Subject: **PART 573— DEFECT AND NONCOMPLIANCE REPORTS**
Emergency Window Handle pull force, installed in Orion buses

PART 573 Defect and Noncompliance Report¹

DRAFT Recall Notice

3. Retention Spring

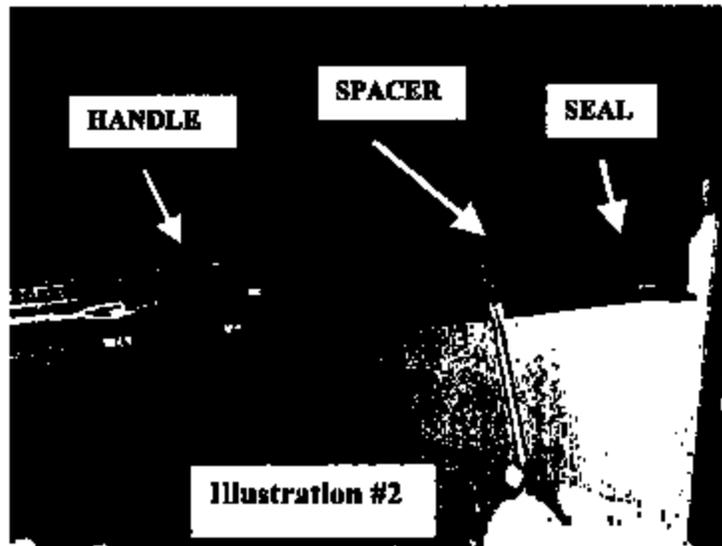
Insufficient glue applied to the wedge block has caused the handle pull force to exceed 89N. The window retention spring was incorrect alignment.

- Visually inspect (Picture to be provided) the two retention springs to ensure that the spring is aligned with the frame (Illustration 1).
- If the spring is not aligned, lightly loosen the two screws and push the retention spring as far as possible towards the exterior of the bus (Picture to be provided).
- Tighten the screws to torque (To be provided)

Metering of glue to hold the wedge block in place and quality control checks ensure blocks do not dislodge. A jig locates the spring before tightening of the two screws.
